Proposed License Condition

Revised June 16, 1980

FIGURE 5.1 CHART OF ORGANIZATION

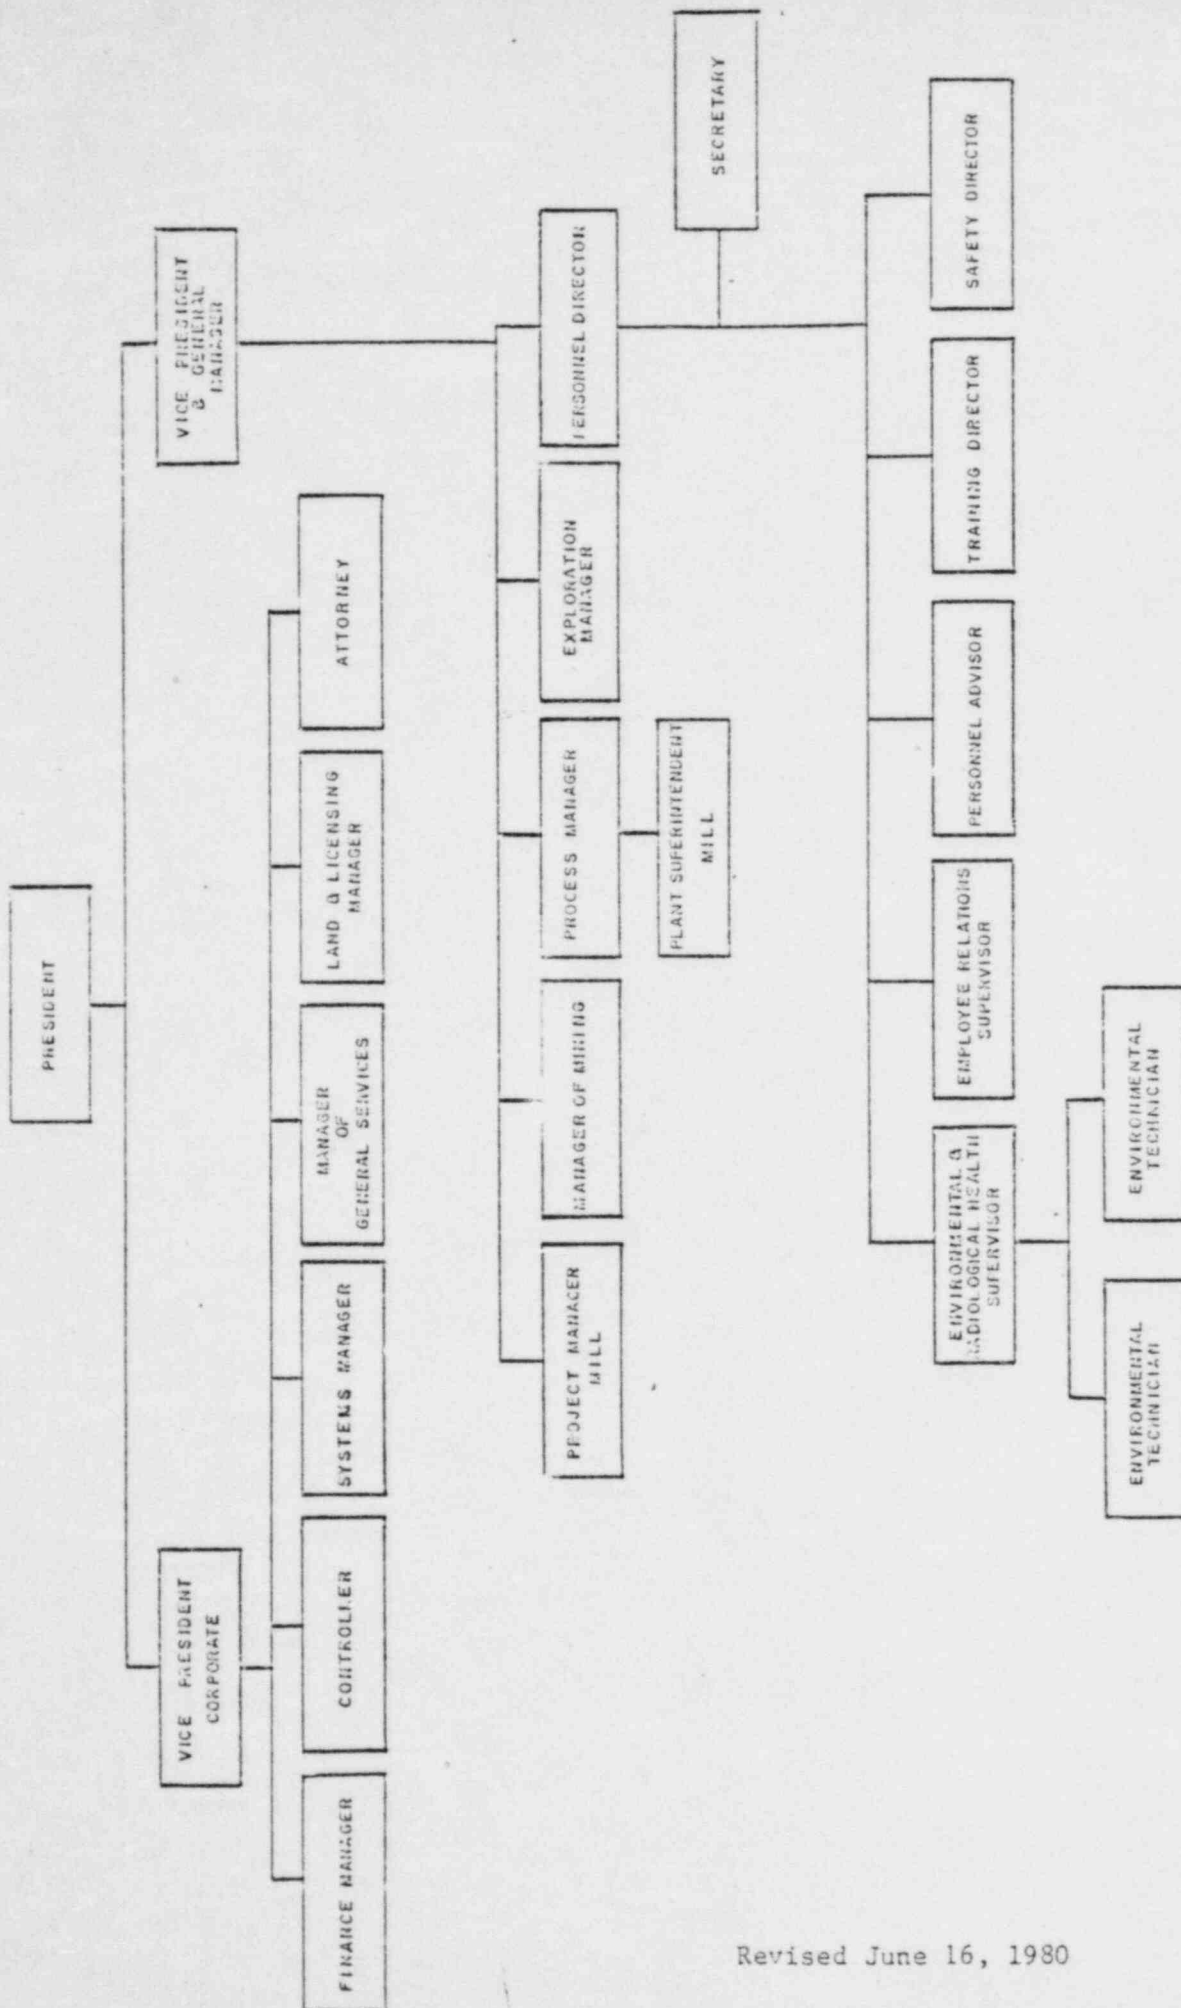
5.1.1 Figure 5-1 shows the corporate organization of Plateau Resources Limited. The Vice President and General Manager of Plateau Resources Limited has responsibility for the processing facility construction and operation. He has full authority to deal with all problems related to operation of the Shooting Canyon processing facility. The Vice President and the General Manager also has responsibility for the overall quality control and assurance programs for the facility. The Corporate Vice President, through the General Services Manager, uses the Quality Assurance Section to perform audits and reviews as part of the Management Control Program.

The Environmental and Radiological Health Supervisor reports to the Personnel Director and has responsibility and authority to develop and implement the environmental and radiological health and safety programs, including preparation and maintenance of written operating procedures for the radiation safety and environmental monitoring and control programs. He supervises all
